Subject: Byron Station Units 1 and 2
Braidwood Station Units 1 and 2
Battery Area Woven Wire Fences
NRC Docket Nos. 50-454/455 and
50-456/457

Inspection Report Nos. 50-456/83-17; 50-457 (83-16)

Item 3 - Inspection of Safety-Related 125 Volt DC Battery
Areas for Unit 1 and 2

Figure b-1: Miscellaneous Electric Equipment Room
(and Battery Area) Ventilation System
(Typical)

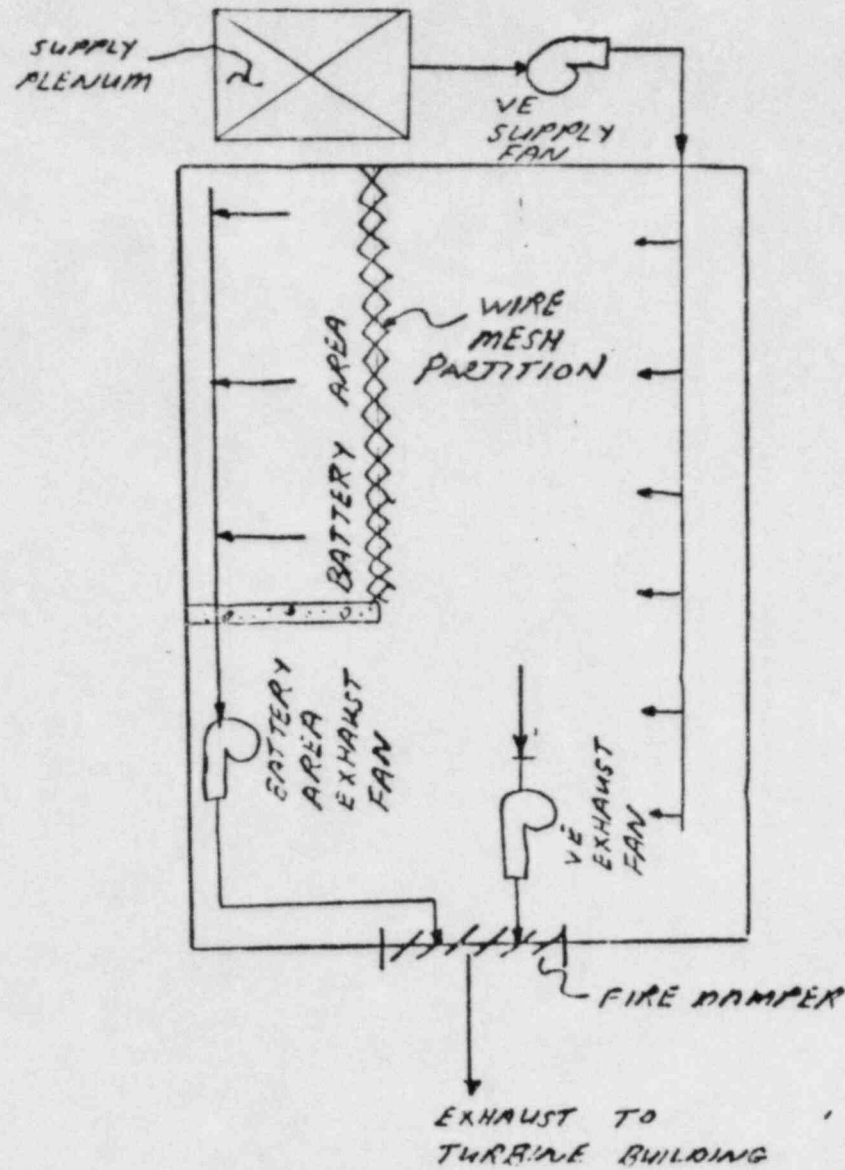
"The 'as built' condition of the 125 volt dc safety-related battery banks at Byron and Braidwood are not enclosed by a battery room with three hour fire rated wall as recommended by Appendix A of Branch Technical Position 9.5-1 paragraph C.7.8. The battery alcove which now has become a part of the electrical equipment and switchgear room may permit hydrogen and other gases liberated from the battery cells to free flow in undetermined directions. Air and gas movement in the battery alcove is dependent upon the operation of the designed battery room and electrical and switchgear room exhaust systems; however, these systems do not have a positive suction on the total battery area, or all cells. Further, the ventilation system as designed for the battery alcove drops three and one half feet below the ceiling thus leaving

a dead air space for the possible accumulation of hydrogen gas. The adjacent electrical equipment and switchgear rooms have ceiling areas with as much as eight foot of dead air space and are not equipped with explosive-proof electrical circuits and/or explosion-proof electrical motors for the exhaust fans. These fans are now part of the ventilation system committed to remove hydrogen gas.

The primary concern, as described in this section of the report, relates to the adequacy of the design of the battery area ventilation system; i.e., the ability of the ventilation system to prevent the accumulation of hydrogen gas in the battery area, and in the adjacent Miscellaneous Electric Equipment Room, in sufficient quantities to create a potentially explosive mixture. The following discussion is intended to resolve that concern.

Figure b-1 illustrates the equipment arrangement and air flow for the Miscellaneous Electric Equipment Room ventilation system. As previously noted, the safety-related 125V DC Battery Area is a part of the Miscellaneous Electric Equipment Room, which is enclosed by a three-hour fire-rated barrier. The battery area exhaust ventilation system will remove 475 CFM from the battery area. Based on the volume of the battery area, and on the calculated maximum hydrogen evolution rate (which could occur with a failure of the battery charging system), the ventilation system will limit the hydrogen concentration in the battery area to 1.44%; 28% less than the "2% of the total volume of the battery area" allowed by IEEE Std. 484-1981 (which itself is conservative). All of the make-up air for the battery area exhaust is drawn

from the Miscellaneous Electric Equipment Room. In order to purge (i.e., sweep) the total volume of the battery area, the exhaust duct is located adjacent to the wall opposite the wire mesh partition. The exhaust ductwork is located at the highest practical point in the room (i.e., immediately under the intermediate roof structural steel) and extends over the entire length of the rear battery rack.

Even if it is assumed that a fraction of the hydrogen gas (say 30%) escapes to the Miscellaneous Electric Equipment Room, the maximum concentration of hydrogen in this room is 0.022%, which is insignificant in comparison to the maximum allowable design concentration of 2%.

Since this ventilation system will limit the hydrogen concentration in the battery area to less than 2%, "the battery area (per IEEE Std. 484-1981) . . . should be considered non-hazardous, thus special electrical equipment enclosures to prevent fire or explosions should not be necessary." However, to provide additional conservatism, spark-proof fans with explosion-proof motors are provided for the Battery Area Exhaust Fans (1/2VE02C and 1/2VE03C).
